Driveshaft Replacement 40/50

Models Affected

1995 Force 40/50
Serial Number
US 0E123524 thru 0E135075

Figure 1. Driveshaft Date Code

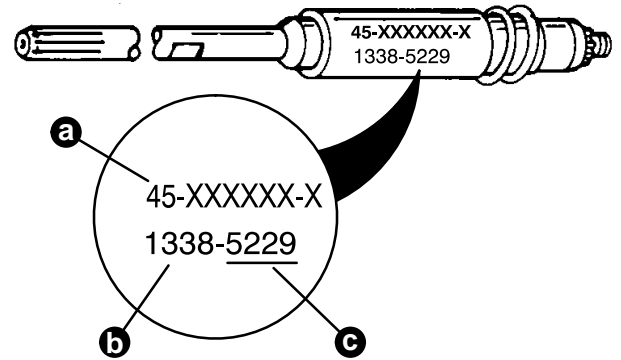
1. Remove gear housing and the driveshaft as outlined in the Outboard Service Manual.
2. Check the date code on the driveshaft per Figure 1.
3. Driveshaft **MUST BE** replaced if the date code is 5190 thru 5233.
4. Order Parts Kit p/n 809796A1 and driveshaft (if required) per this bulletin for reassembly.
5. Reassemble and install the gear housing as outlined in the Outboard Service Manual.
6. Fill the gear housing with Quicksilver gear lube, install the propeller, and check for proper operation of the outboard.

Figure 2. 40/50HP Rework Marking

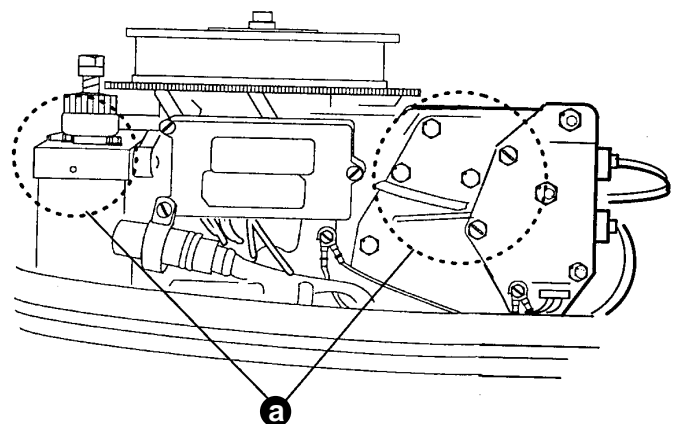
- A red or black letter "D" hand applied with a marker on the outboard serial number label of the shipping carton.
- A yellow dot or marking painted on the powerhead (Figure 2).
